RFIs

Project #: 1730103

Project: MSC Replace AHU's Phase 2 Labs 1 & 2

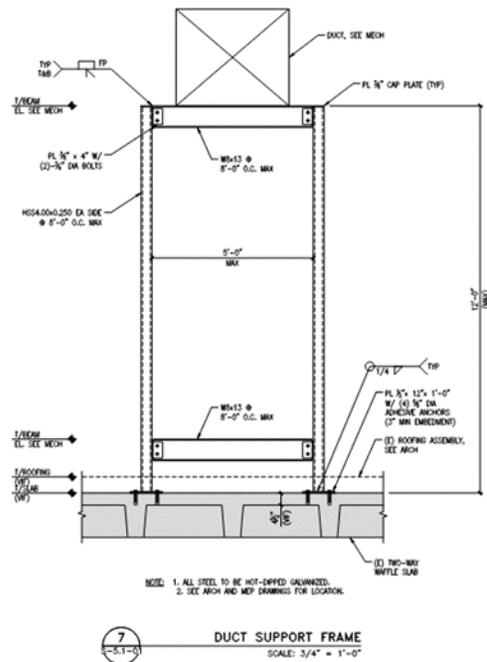
Clarification Question:

- a) Please provide the point of contact for the roofing contractor that holds the existing roof warranty. **Vatica Contracting. 301-927-8530.**
- b) Per the detail below we will have approximately 85-90 supports for the temporary ductwork which will require roof patching, are there any roof repairs associated with the existing temporary supply piping or ductwork we should be aware of? **Coordinate with COTR, the existing temporary duct at roof serving the ongoing project lab-3 and lab-4 should be removed by the current contractor after lab-3 and lab-4 are completed and any damaged to roof cause by this removal should be repaired by the current contractor. Pls note that existing temporary duct at roof, which is the duct elbow after the existing temporary duct riser, will be reused for lab-1 and lab-2 shall remain. With regards to existing temporary piping at roof, they will be reused for existing AC-T1 for lab-1 and lab-2 and will be removed at the end of the project and any damage to roof cause by this removal will be repaired by lab-1 and lab-2 contractor.**

- c) Also referencing the detail below the height given for the supports (12' max) conflicts with the notes on the temporary ductwork drawings (MT-4.10-.02 – MT-4.1-04) in which there is a note for the temporary ductwork to be "15ft above the roof." Please clarify the correct height for the temporary ductwork. **Height varies with maximum height of 15'.**

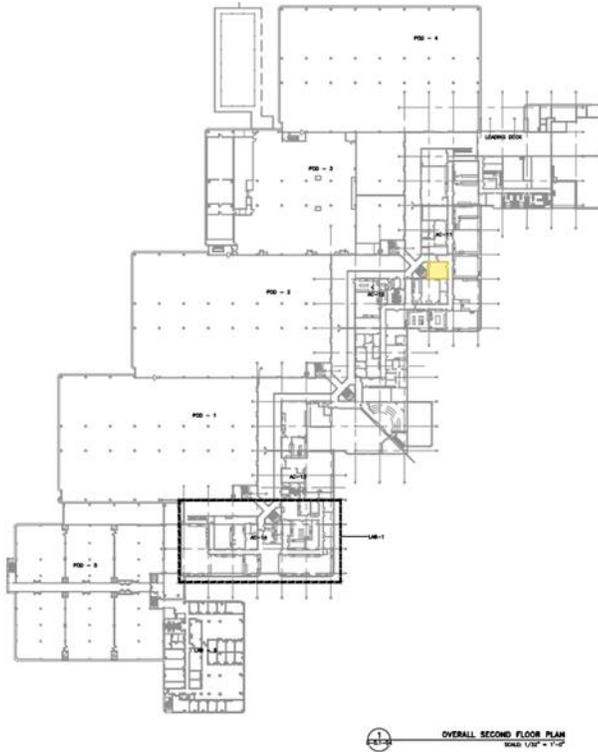
40. **Question:** There is conflicting information outlined in the drawings regarding the government owned and furnished temporary AHU 'AC-T1':

-Lab 2 Drawings sheet M-8.2-01, Phase 4 Note 6 states "Temporary Unit AC-T1, ductwork and piping shall be removed and coordinated with COTR to return/hand over the temporary unit to SI. Clean everything and patch all temporary openings with fire stopping materials to match existing"

-Lab 2 Drawings sheet M-8.2-01 Note 7 states "The government furnished temporary unit system with all associated utilities, piping, ductwork, supports, power, etc. shall be removed completely at the end of project. Coordinate with COTR before removal of temporary unit system."

At the end of project, does the temporary AHU remain onsite where currently installed from the previous Lab 3/4 project for SI to relocate or remove from site? Or is the Contractor required to disassemble, demo, and remove AC-T1 from site?

Answer: Contractor is required to remove, disassemble, demo and remove AC-T1 from site. Coordinate with COTR before removal of temporary unit system.

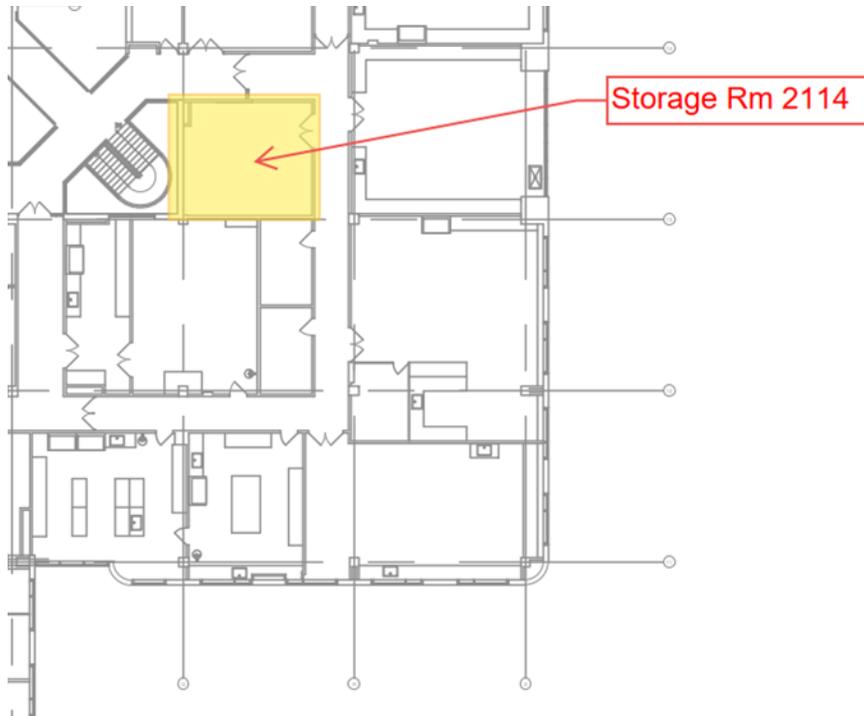
41. **Question:** The LMLAB panelboards and T30 transformers are shown to be fed from panelboard HDPLAB located in room E2114. This panelboard and room number are not shown on Lab 1 & 2 contract drawings. Please indicate on an overall floor plan drawing where room E2114 is located.

Answer: Room E2114 is on the 2nd floor, located in the Lab 3 area of the facility. See snippets below.
